| Well Name: POKER LAKE UNIT 22 DTD | Well Location: T24S / R30E / SEC 22 / NENW / | County or Parish/State: |
| Well Number: 182H | Type of Well: CONVENTIONAL GAS WELL | Allottee or Tribe Name: |

Sundry ID: 2761880

Type of Action: APD Change

WELL LOCATION AND ACREAGE DEDICATION PLAT

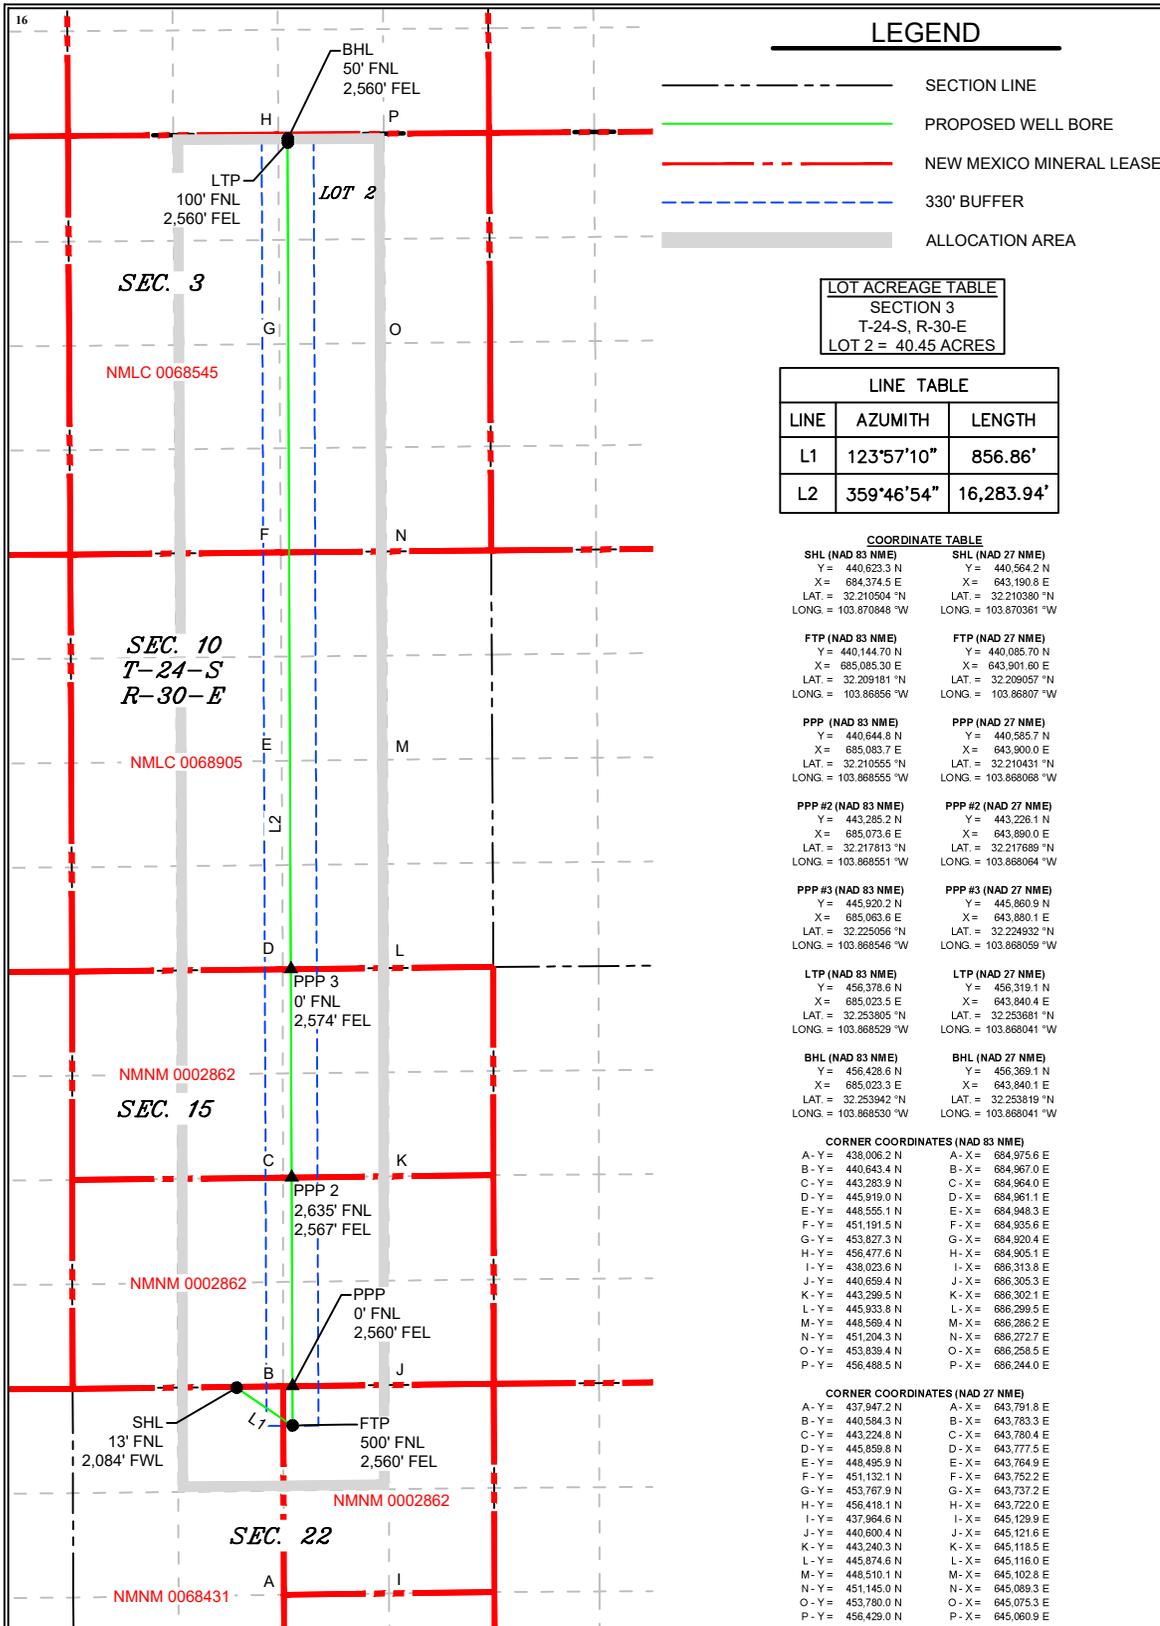
SHL: FROM: 203 FNL & 1596 FWL TO: 13 FNL & 2084 FWL of Section 22-T24S-R30E

BHL: FROM: 198 FNL & 1769 FWL TO: 50 FNL & 2560 FEL of Section 3-T24S-R30E

FTP: FROM: 100 FNL & 1770 FWL TO: 500 FNL & 2560 FEL of Section 22-T24S-R30E

LTP: FROM: 328 FNL & 1769 FWL TO: 330 FNL & 2560 FEL of Section 3-T24S-R30E

| UL or lot no. C | Section 22 | Township 24S | Range 30E | Lot Idn | Feet from the 13 | North/South line NORTH | Feet from the 2,084 | East/West line WEST | County EDDY |

| UL or lot no. 2 | Section 3 | Township 24S | Range 30E | Lot Idn | Feet from the 50 | North/South line NORTH | Feet from the 2,560 | East/West line EAST | County EDDY |
